Route Access Condition Notice 18-00012

Distributed To:	ARTC Website
Distribution Date:	16/04/18
Requested By:	ARTC
Subject:	Branxton Review
Effective Period:	Until Published
Amendment Type:	Permanent (to be added to RAS)

Details: Speed Board Review

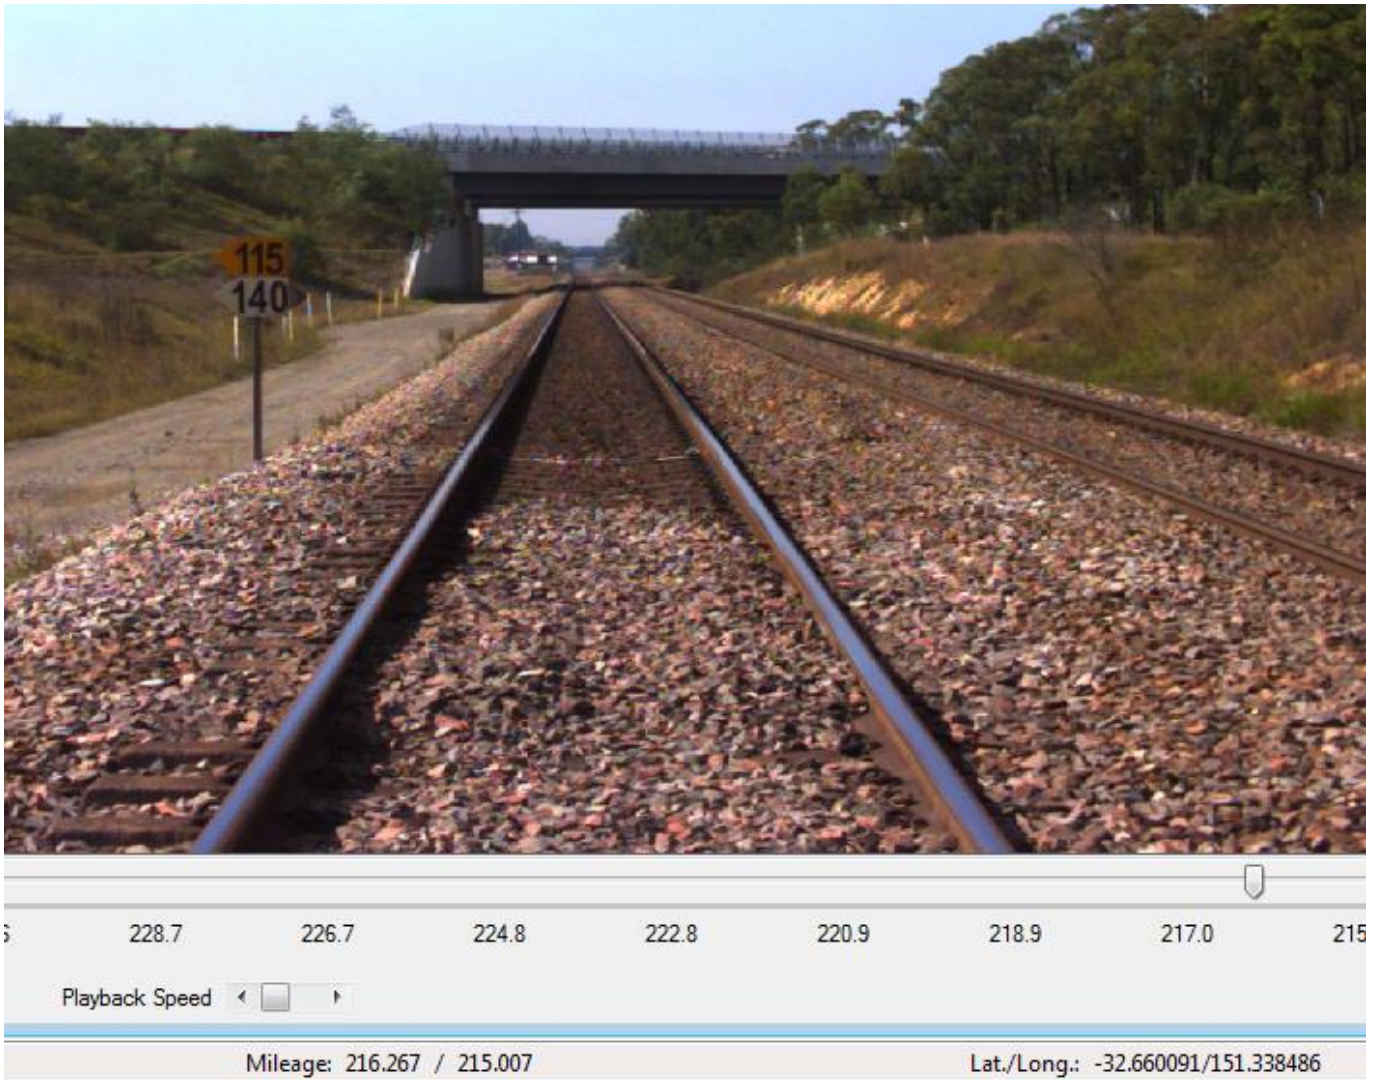
Comment [RP1]: RACN1800012 as per Will Headon Email

The 115/140 at 216.260 shows it is in the Down direction in the location but this is an Up speed, Pic below

ISLINGTON JUNCTION – MUSWELLBROOK (MAIN LINE)					
LOCATION	KILOMETRAGE	DOWN		UP	
		NORMAL	XPT	NORMAL	XPT
	216.206			X70	X85
BRANXTON					
DOWN direction ON UP MAIN				(85)	(85)
DOWN direction ON UP MAIN	216.260			115	140
	216.286	X85	X85		
DOWN direction ON UP MAIN	216.436	(X85)	(X85)		
UP RELIEF SPEED	216.660			85	90
DOWN direction ON UP MAIN	216.680			(115)	(125)
	216.680			85	85
UP direction ON DOWN MAIN	218.380	(115)	(135)		
UP RELIEF SPEED	218.673			100	120
DOWN direction ON UP MAIN	218.680			(105)	(110)
	219.880	95	110
